VILLAGE OF MORTON GROVE
APPEARANCE COMMISSION

Tuesday, June 3, 2025 - 7:00 P.M.
AGENDA

CASE AC 25-07

CASE AC 25-08

Awnings removed from West and North Façades

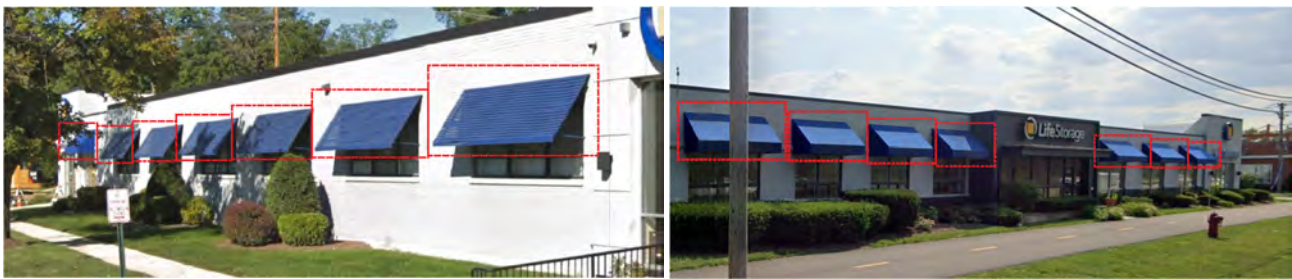
Blue awnings were removed by the applicant and that work did not require a permit. An Appearance Certificate is also not required for the awnings as their removal is a change to the façade of an industrial building within a manufacturing district. Appearance Commission review is only required for projects requiring a building permit or for changes to an exterior color within a commercial district.

Proposed Monument Sign Size (Left) and Location (Right – Labeled '1')

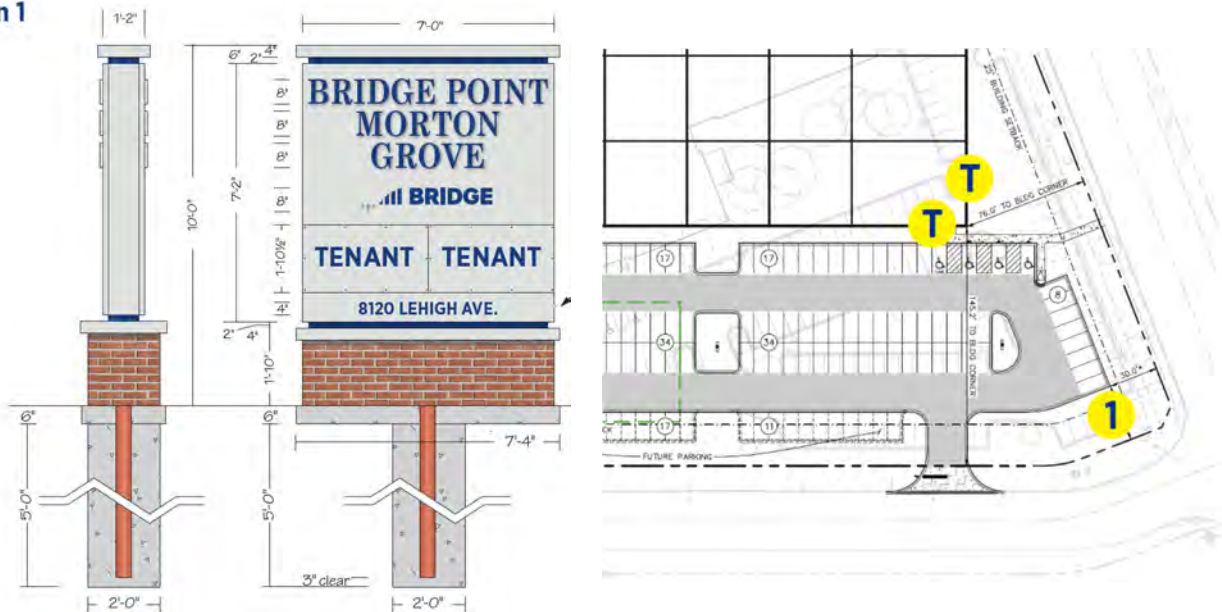
The proposed monument sign would be ten feet (10') tall with a sign area of 50.2 sq. ft. The proposed sign is required to be located at least five feet (5') from the public right of way along Park Avenue and Lehigh Avenue. The sign plan does not provide the precise location of the proposed monument sign, but there appears to be sufficient space for a compliant sign location given that the parking lot is located 30 feet (30') from either right of way. A landscape bed extending two feet (2') from the sign base is required, but not provided for in the sign plan. ***The applicant should speak to the proposed sign location, proposed landscaping, and confirm whether related waivers are requested.***

Proposed Address Sign

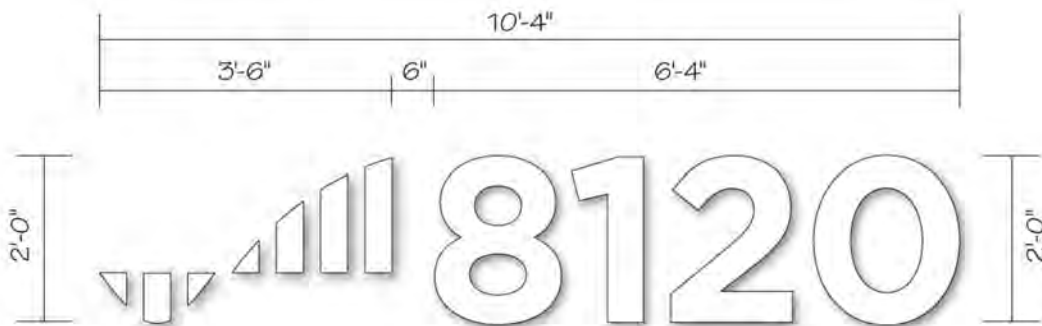
The address sign would consist of a Bridge Development logo and street number and would be 20.7 sq. ft. The address sign would be constructed of one inch (1") thick acrylic that is painted white and flush mounted to the building. The proposed sign is in excess of the two (2) sq. ft. maximum permitted, however Staff note that the sign size is proportional to the building and are not concerned with the request. Similarly sized address numbers are located on other industrial buildings in the area and the Bridge Development logo measures seven (7) sq. ft. which is smaller than tenant signage typically permitted.
